City of South Haven

NEWS RELEASE

Erie/Monroe/St. Joseph Corridor proposed traffic control change

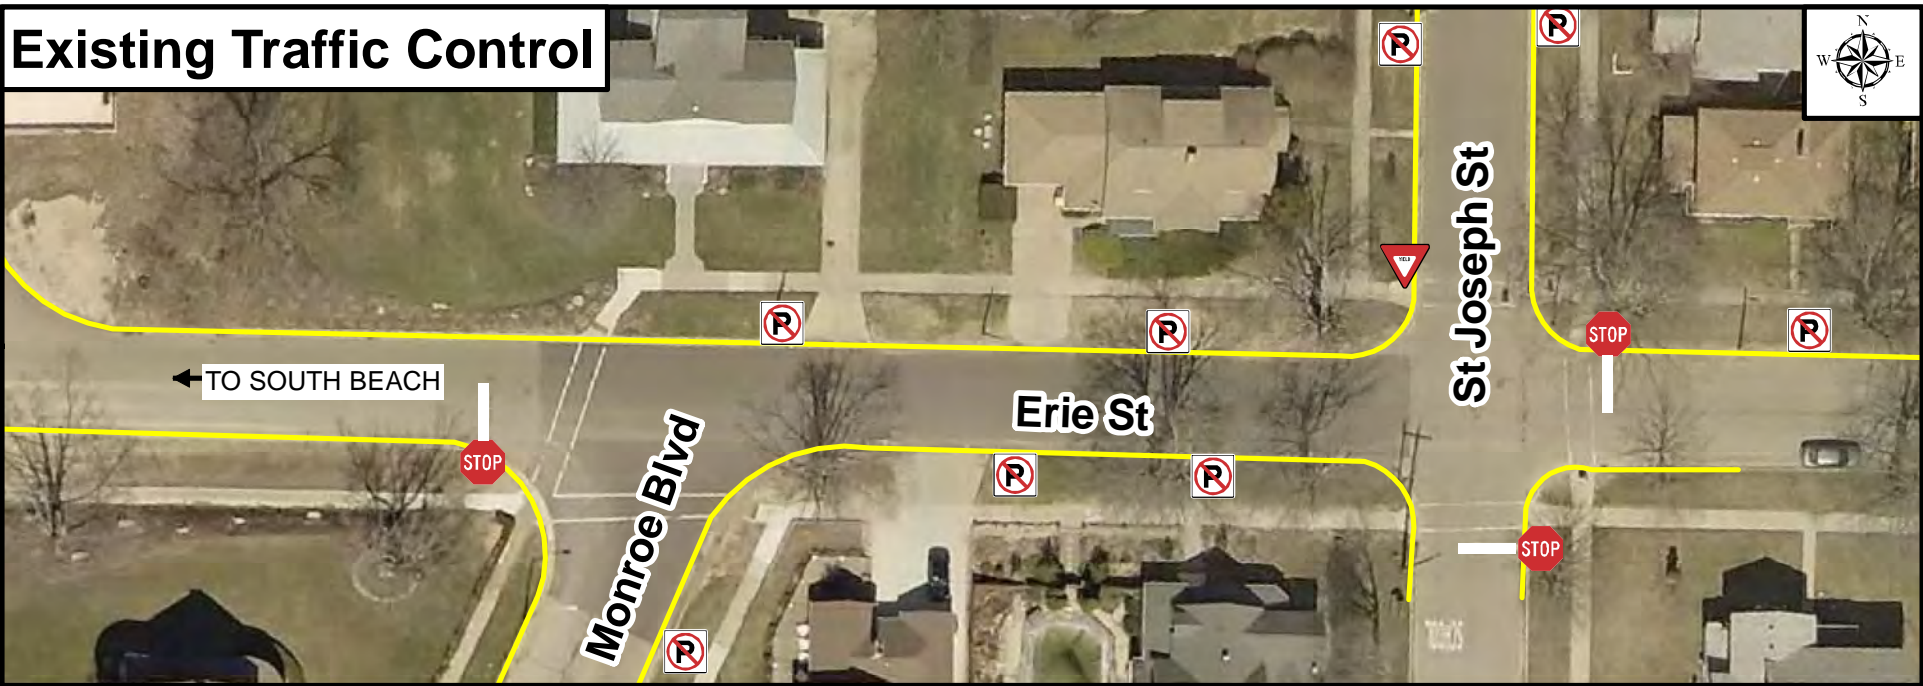
- Remove the current stop sign and stop bar on the eastbound Erie approach
- Place a stop sign and applicable stop bar on the northbound Monroe approach (with temporary sign flagging/other to enhance driver recognition)

- Remove stop sign and stop bar on westbound Erie approach
- Replace the existing yield sign on southbound St. Joseph with a stop sign (with temporary sign flagging/other to enhance driver recognition) and add a stop bar
